Access Compliance Report

Public Rights-of-Way

(Curb Ramps)

Intersection ID: 14226	Main Street: AROSA_AV	Cross Street: E_MOREHEAD_ST	Location: W
ADA ID: 6F155F89B7DA	Ramp Type: PerpDiag	Initial Pass/Fail: Pass	Overall Compliance: No
		Severity Score: 7.5

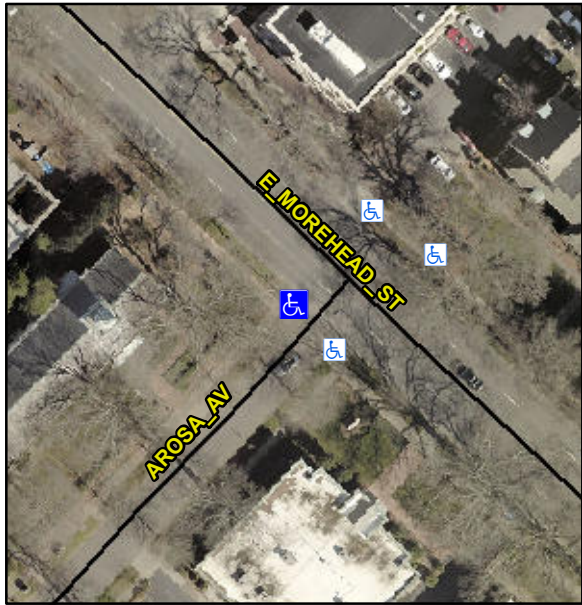
Codes/Mitigation Info/Possible Solution			Field Measurements/Component Compliance					
	Possible Solutions:		Compliance	Description	Data	Compliance	Description	Data
	Remove & Replace Detectable Warning System. Remove & Replace Gutter.		N/A	Ramp Length (in)	108.0	Yes	Ramp Slope (%)	7.0
			Yes	Ramp Width (in)	49.0	Yes	Ramp XSlope (%)	1.6
			N/A	Flare Type LT	Sloped	N/A	Flare Type RT	N/A
			N/A	Flare Slope LT (%)	8.1	N/A	Flare Slope RT (%)	3.3
			N/A	Flare Traversable LT?	Yes	N/A	Flare Traversable RT?	No
			Yes	Landing Length (in)	48.0	Yes	DWS Provided?	Yes
			Yes	Landing Width (in)	49.0	Yes	DWS Contrast?	Yes
			Yes	Landing Slope (%)	1.6	Yes	DWS Length (in)	24.0
			Yes	Landing X Slope (%)	0.9	No	DWS Full Width?	No
Surveyor Notes: N/A PROW/ADA: R305.1.4, R305.2, R302.7, R304.5.4			N/A	Landing Curb? (Y/N)	No	No	DWS Offset (in)	10.0
			N/A	Shared Landing?	No			
			No	Gutter Ponding?	Yes	No	Gutter Slope (%)	7.1

Yes	Gutter Lip Ht (in)	0.0	Yes	Gutter X Slope (%)	0.9
			N/A	Painted X Walk1?	No	N/A	Painted X Walk2?	No
				X Walk 1 Direction	To SE		X Walk 2 Direction	To NE
			N/A	X Walk 1 Width (in)	N/A	N/A	X Walk 2 Width (in)	N/A
				X Walk 1 Slope (%)	1.6		X Walk 2 Slope (%)	2.9
				X Walk 1 X Slope (%)	1.5		X Walk 2 X Slope (%)	2.6
			N/A	Ramp inside XWalk1?	N/A	N/A	Ramp inside XWalk2?	N/A
			Road Slope (%)	0.1	N/A	Clear Space?	Yes	
			Road X Slope (%)	3.3	N/A	Clear Space to XWalk (in)	N/A	
		Yes	Any Obstructions?	No	Yes	Storm Grate/Utility Hazard?	No	
			Obstruction Type			Storm Grate/Utility Type		
					N/A			N/A
						Yes	Surface Condition? (G/P)	Good
